Addendum No. 1

*Farmers Alliance Mutual Insurance
1122 North Main Street
McPherson, Kansas 67460*

Architect's Project Number: 22.31

Addendum No. 1 (Articles 1.1 thru 1.14) 2 Pages + Attachments

WALL, DOOR & WINDOW SCHEDULES

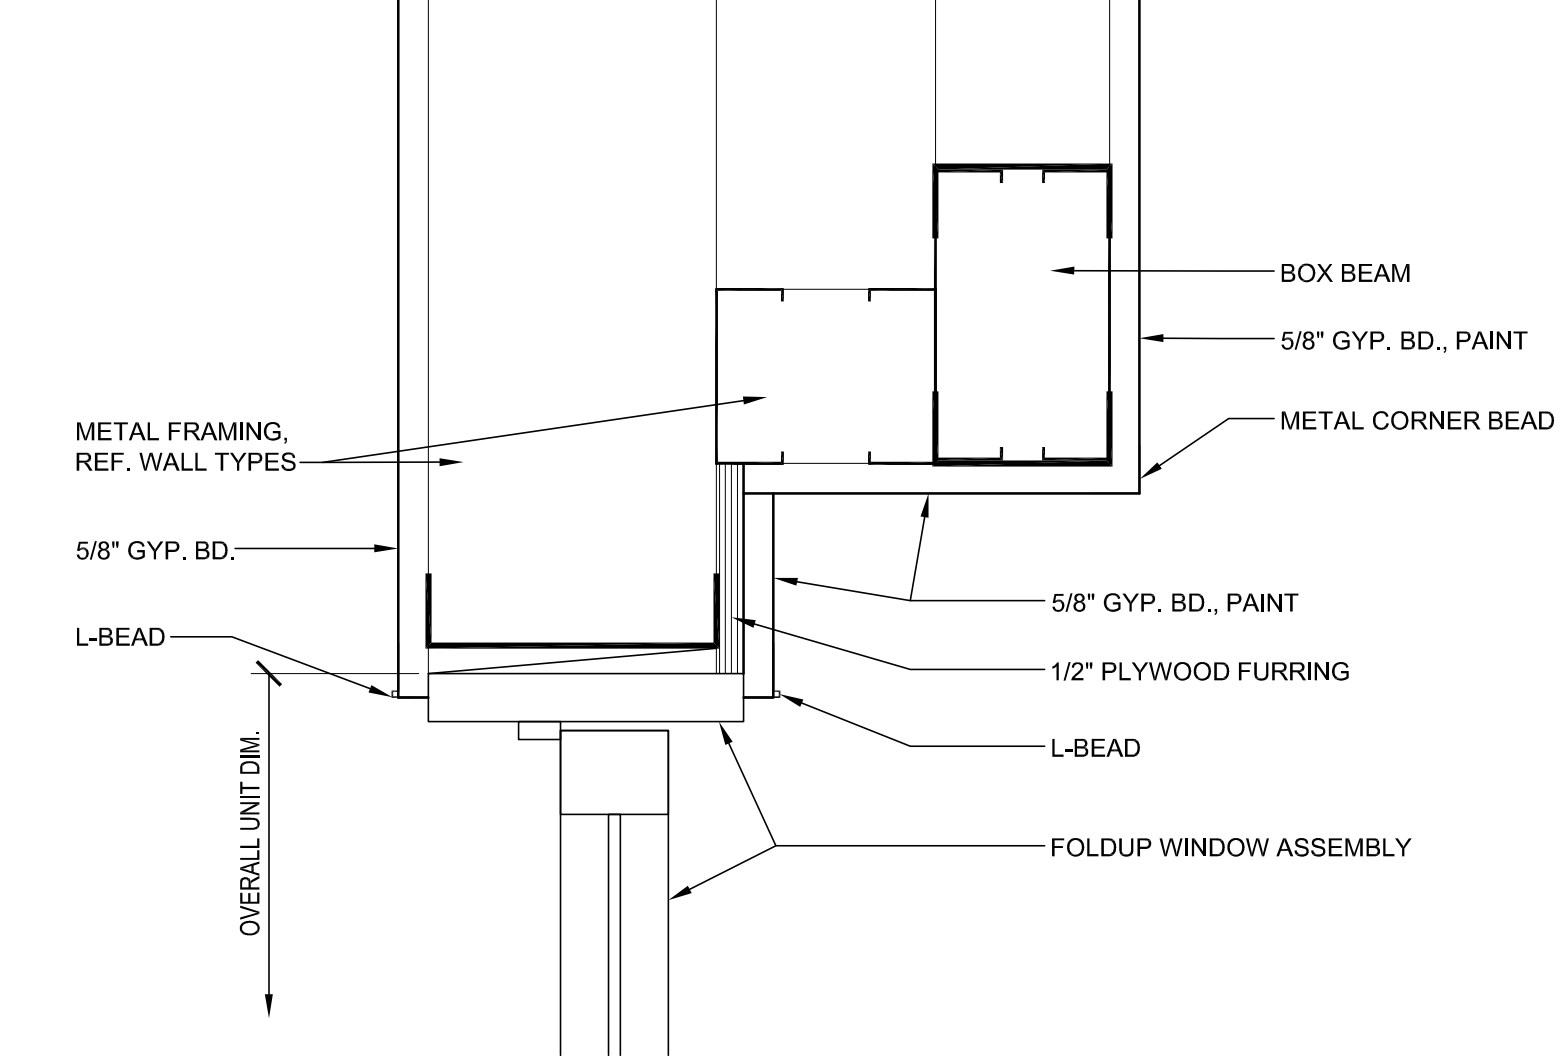
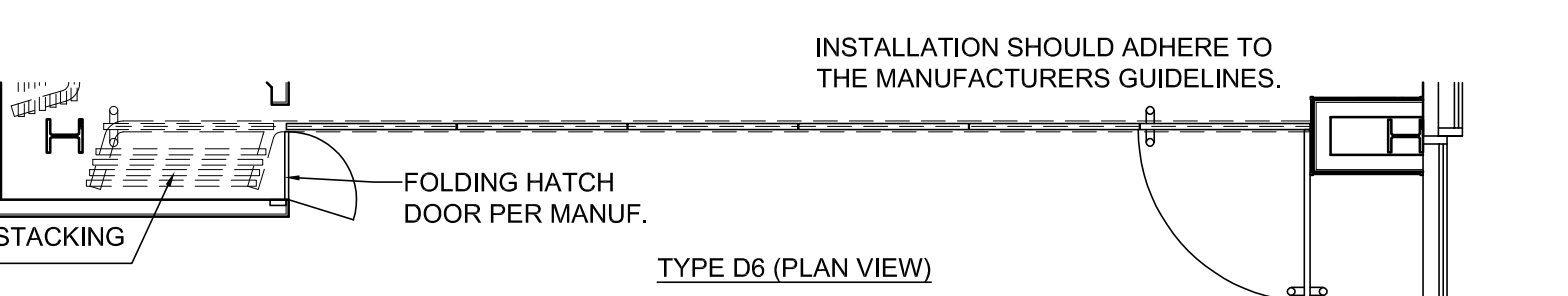
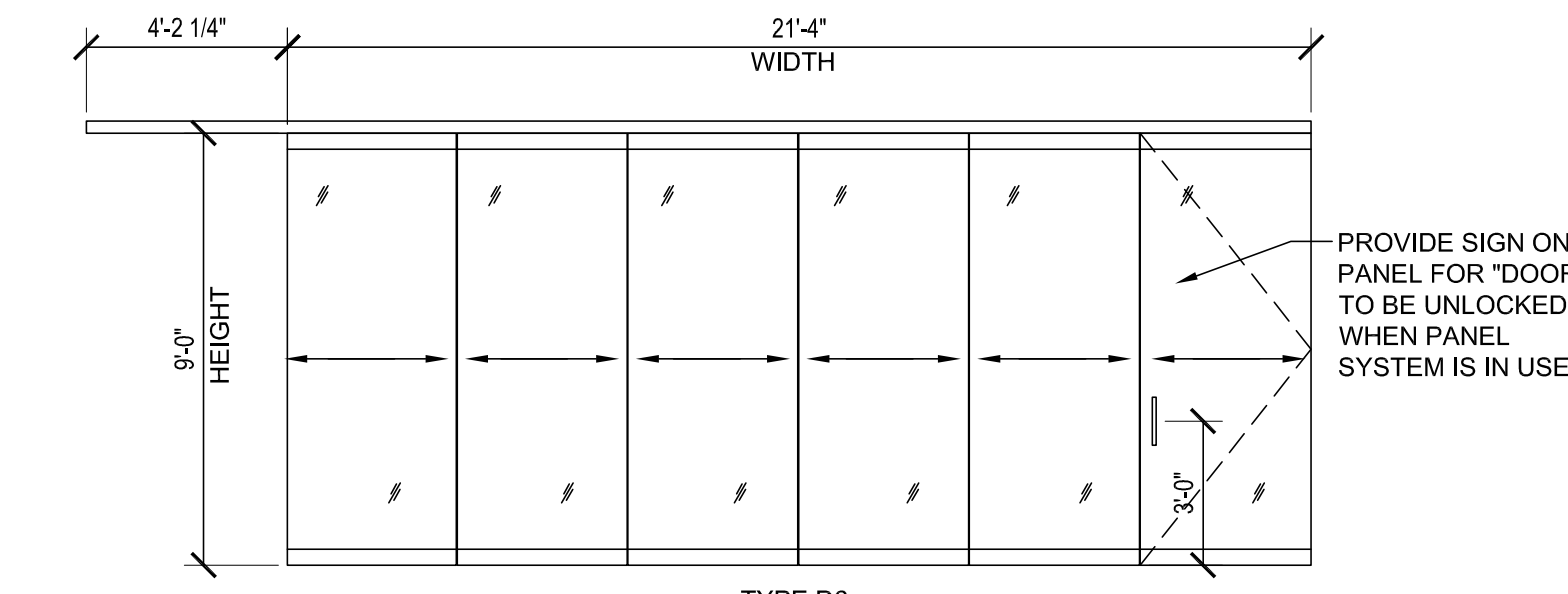
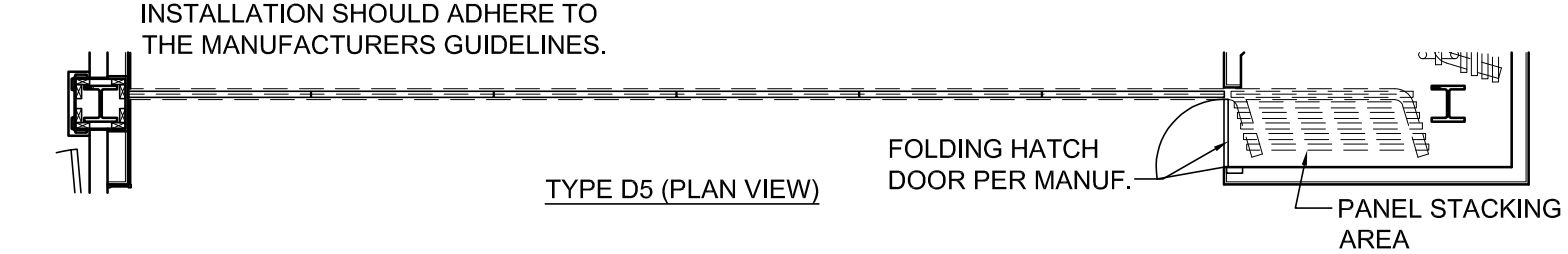
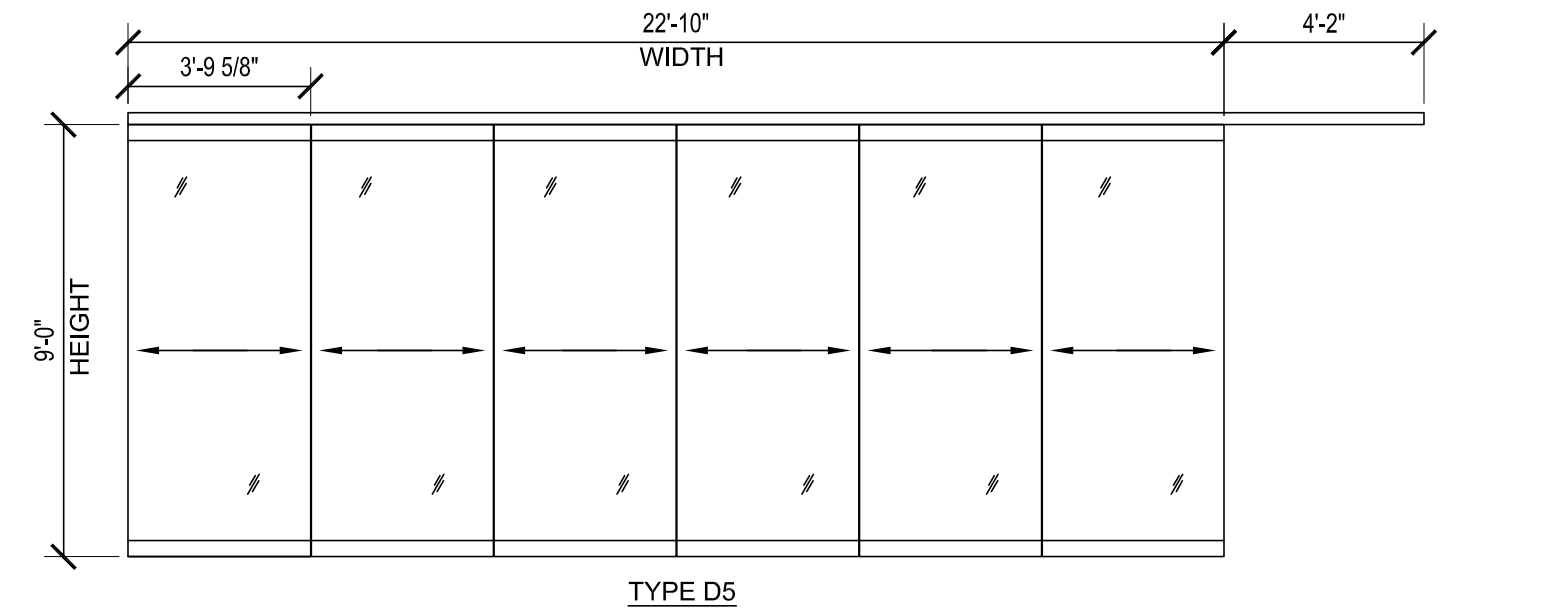
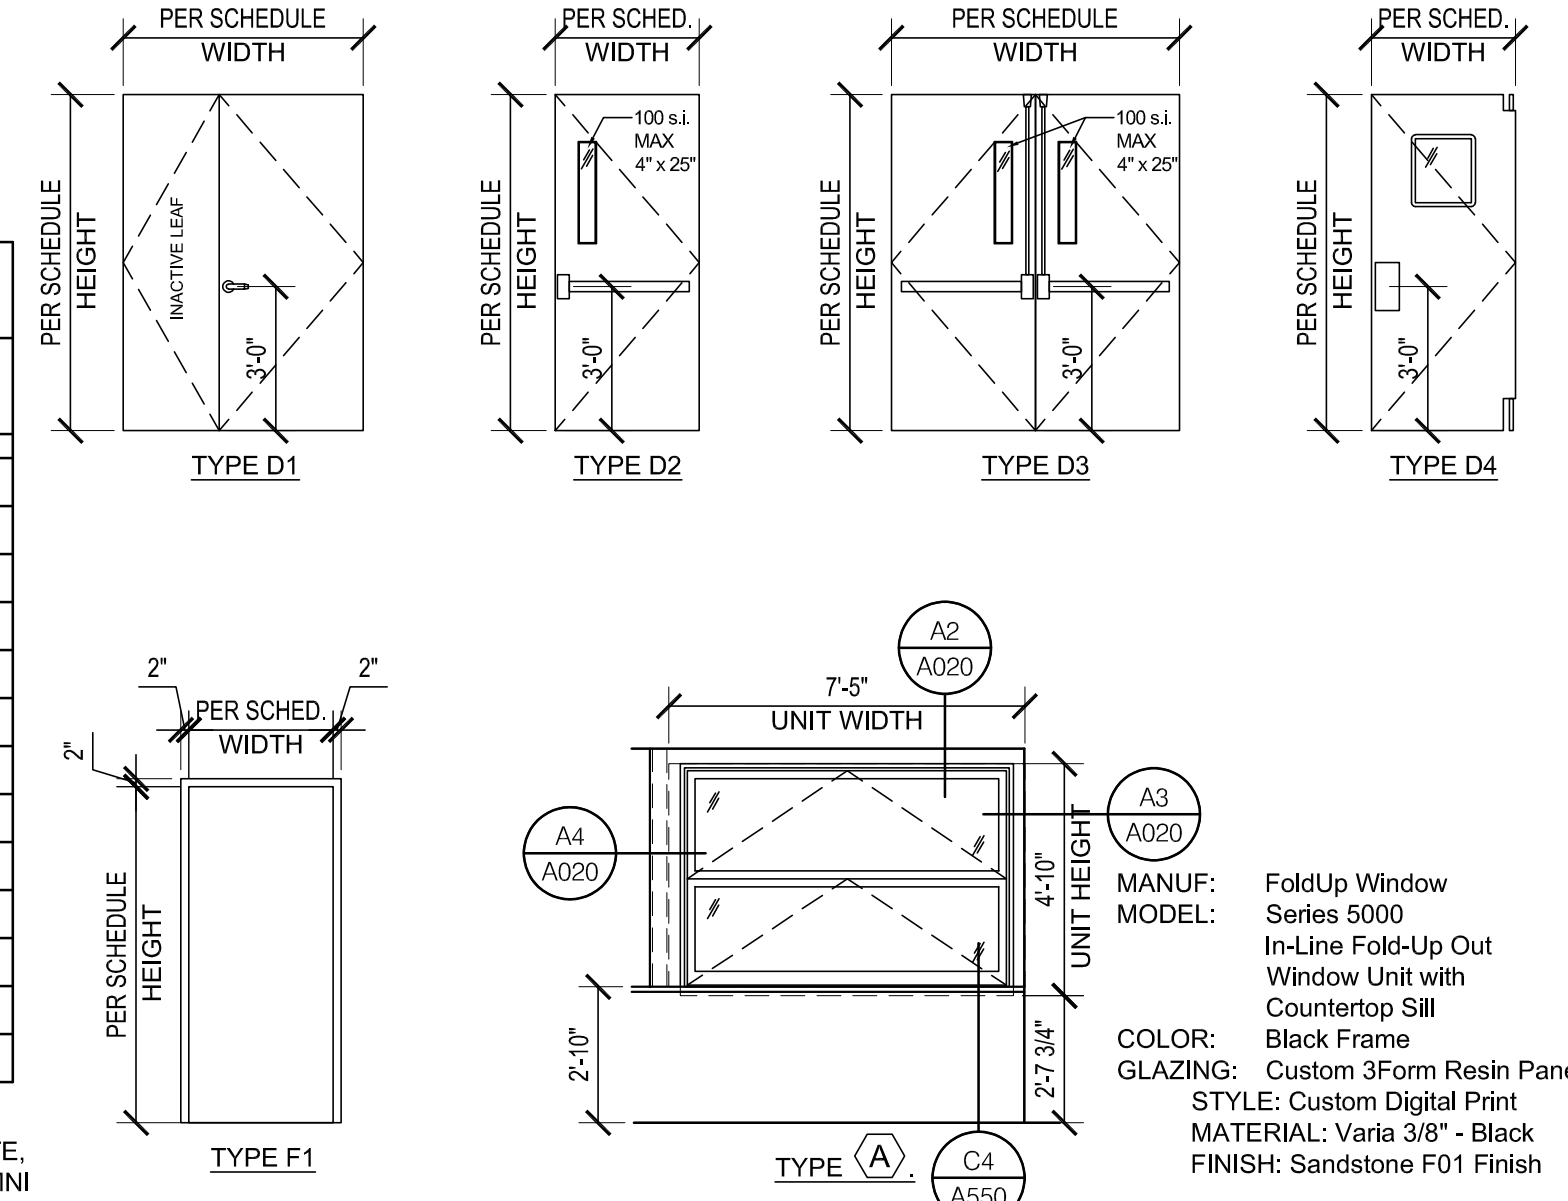
Article 1.10. Architectural: A020 Wall, Door & Window Schedule (See Attached)

- A. **Revise:** Door 201/01 – Width = 5'-0"
- B. **Revise:** Door Schedule – Note 2, "...PREP FOR NEW PAINT."

Response: Door 201/01 is a 5'-0" opening with a 3' and 2' door leaf with the 2' leaf being inactive. This door is to be rated and door hardware will be updated per spec.

A3 FLOOR PLAN
SCALE: 3/16"=1'-0"

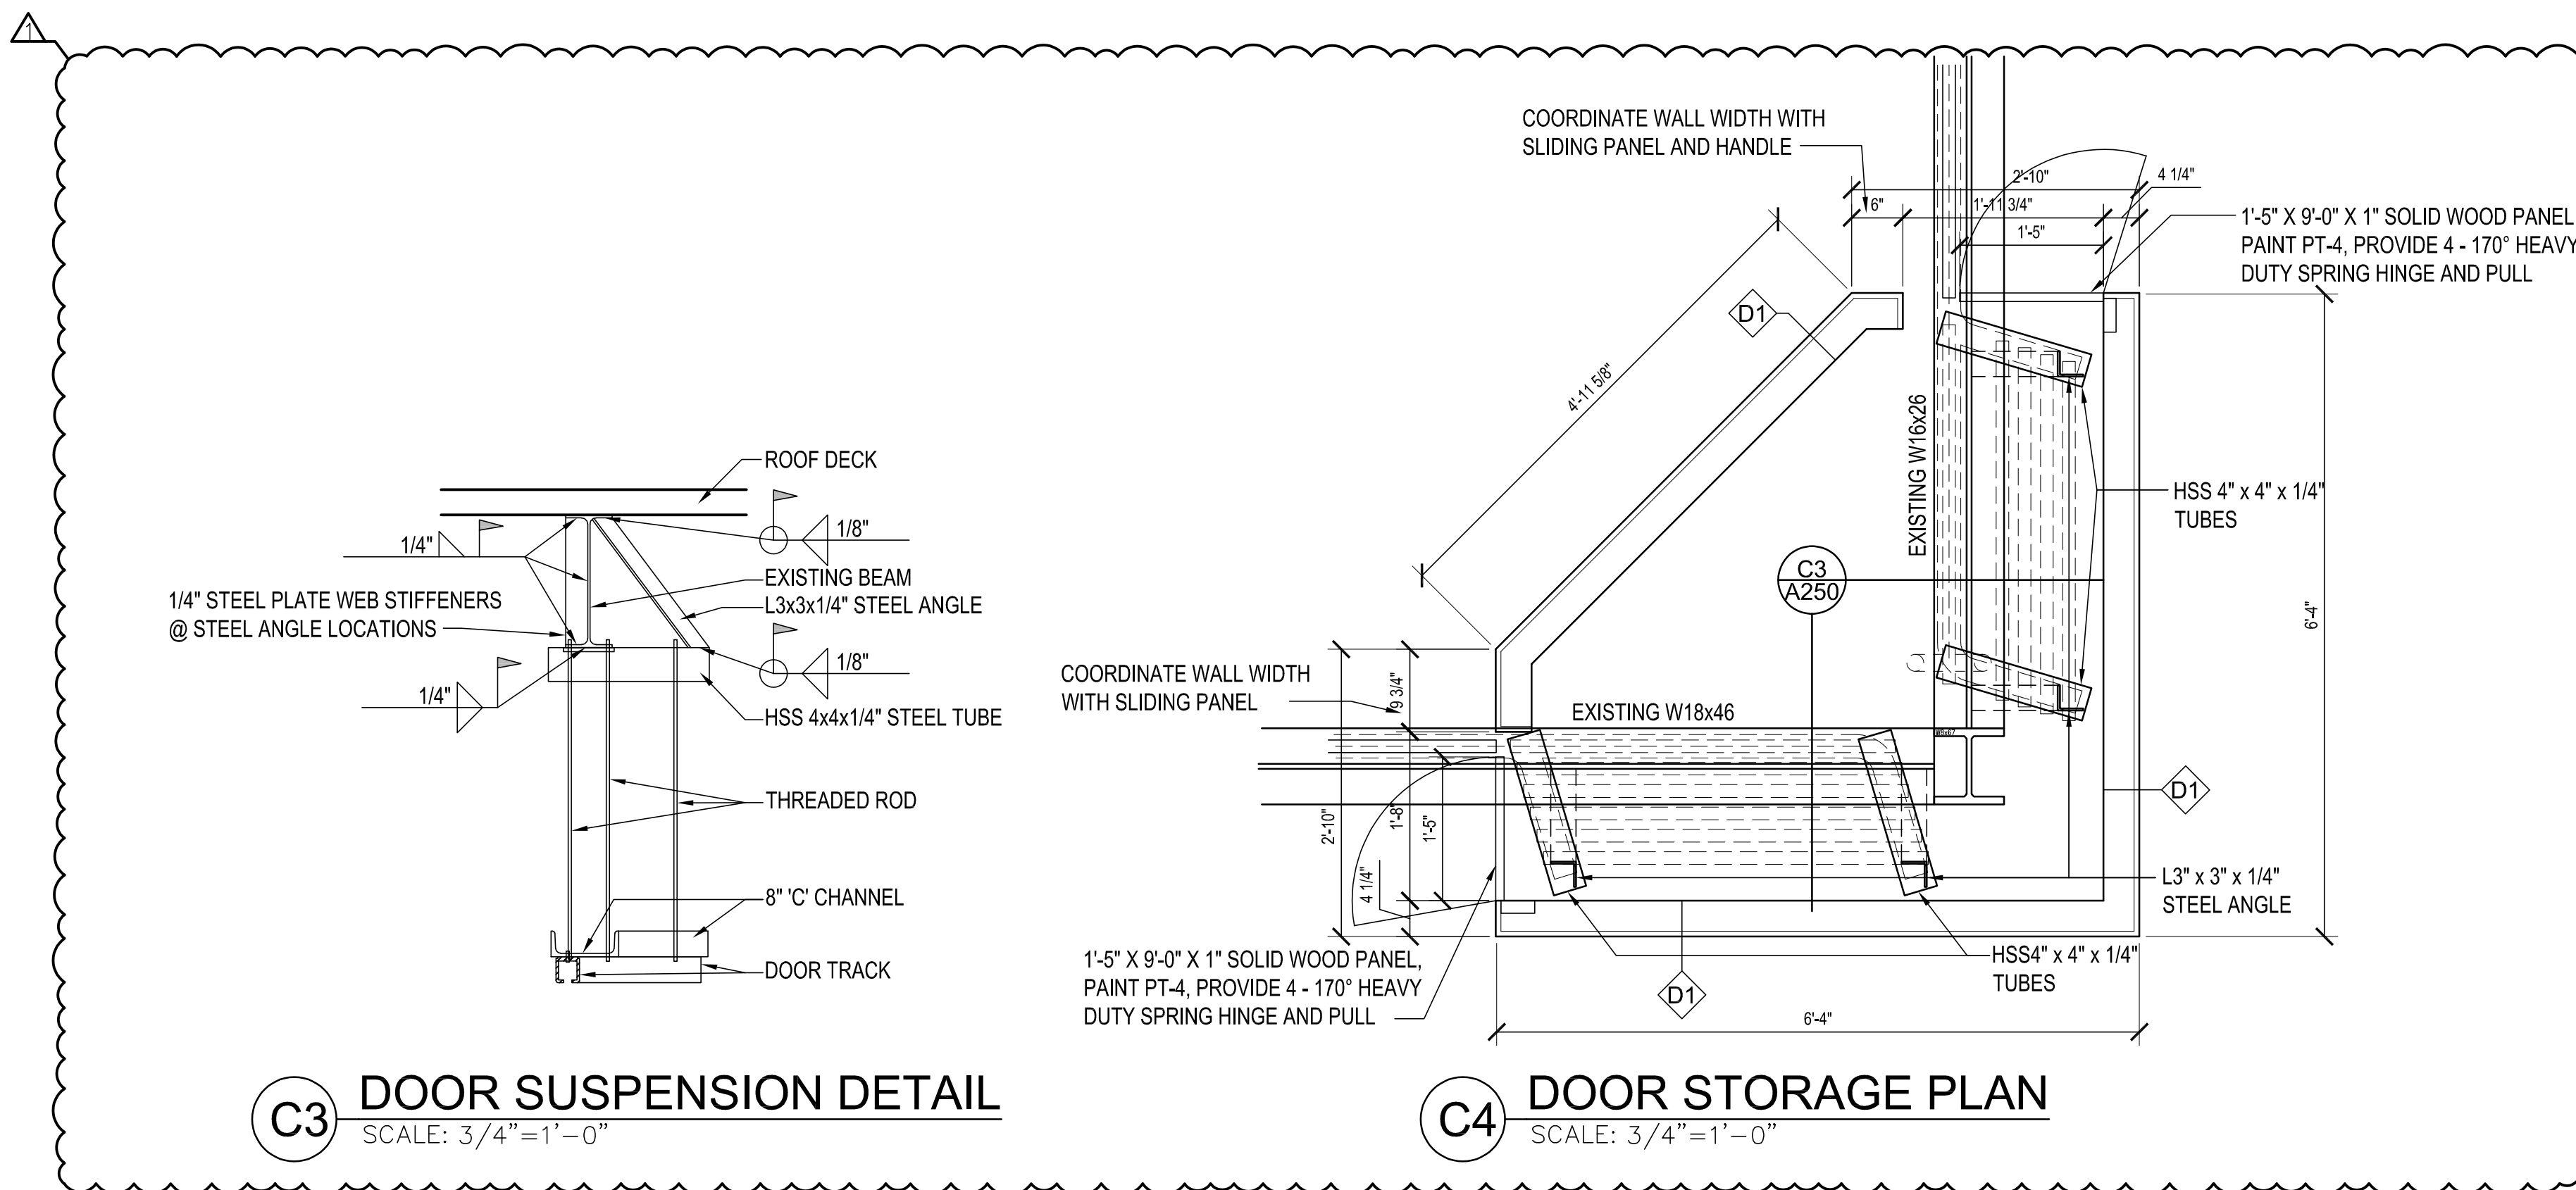
Article 1.11. Architectural: A102 Floor Plan (See Attached)

- A. **Revise:** Plan Keynote 3 to add "TV: LG UHD UQ75 Series 43" Smart TV".
- B. **Revise:** Relabel building section keynote to B3/A250.
